Title of Change:	The change is to improve product package robustness by changing of ICD2PAK 5LD from dual gauge to single gauge frame, change leadframe material from KFC material to HCL-12S, add in mold lock on the heatsink and change mold compound from G600 to G700HF.
Proposed Changed Material First Ship Date:	31 Aug 2023 or earlier if approved by customer
Current Material Last Order Date:	31 Jul 2023 <i>Orders received after the Current Material Last Order Date expiration are to be considered as orders for new changed material as described in this PCN. Orders for current (unchanged) material after this date will be per mutual agreement and current material inventory availability.</i>
Current Material Last Delivery Date:	30 Aug 2023 <i>The Current Material Last Delivery Date may be subject to change based on build and depletion of the current (unchanged) material inventory</i>
Product Category:	Active components – Integrated circuits

Final Product/Process Change Notification

Document #:FPCN23071ZA

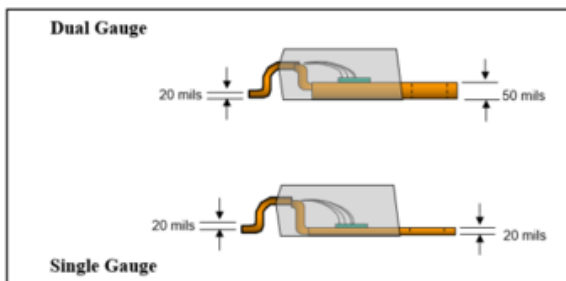
To notify customers of the change in leadframe supplier from KOBE to SDI, change leadframe material from KFC to HCL-12S, heatsink thickness from 50mils to 20mils, add in mold lock design on heatsink and change mold compound from G600 to G700HF.

Item	Before Change Description	After Change Description
LeadFrame	Leadframe supplier: KOBE Leadframe material: KFC Heatsink thickness: Dual Gauges (50mils) Heatsink area: No mold lock	Leadframe supplier: SDI Leadframe material: HCL-12S Heatsink thickness: Single Gauge (20mils) Heatsink area: add in mold lock
Mold Compound	G600 Compound supplier: Sumitomo	G700HF Compound supplier: Sumitomo
Package case outline	DETAIL C TIP LEADFORM ROTATED 90° CW CASE 936A-02 Issue D Heatsink Thickness ED: 1.143-1.397mm Package thickness (C): 4.318-4.572mm	DETAIL C TIP LEADFORM ROTATED 90° CW CASE 936A-02 Issue E Heatsink Thickness Es: 0.457-0.660mm Package thickness (C): 4.318-4.572mm *Detail C and all the other dimension remain same.
